From: Anna Kramarczyk <Anna.Kramarczyk@midsussex.gov.uk>
Sent: 22 December 2025 18:33:02 UTC+00:00
To: "Steven King" <Steven.King@midsussex.gov.uk>
Subject: Re: DM/25/3203 Proposal Discharge of planning condition 13 Part A, C, E and F and planning condition 23 relating to DM/23/0810

Re: DM/25/3203 Proposal Discharge of planning condition 13 Part A, C, E and F and planning condition 23 relating to DM/23/0810
Based on the recently submitted information please see my comments in [Blue](#);

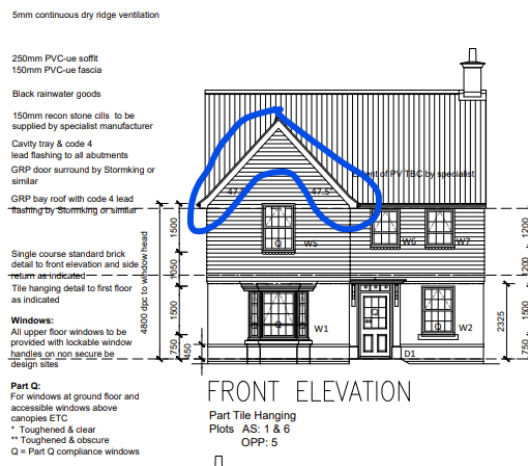
- Regarding facing materials and their applications there seem to be some discrepancies between the drawings. However, provided set of the elevations show the facing materials being applied as per Material Plan which is welcomed.

Nearly all elevations are acceptable subject to minor changes/correction listed below:.

- The FAIFBURN house (plots 1, 6 and opp. 5). I have doubts about the use of uPVC fascia and soffit at the those gable fronts (these units are located at the site entrance and are closing the vista) and would like this one detail to be revisited and improved.
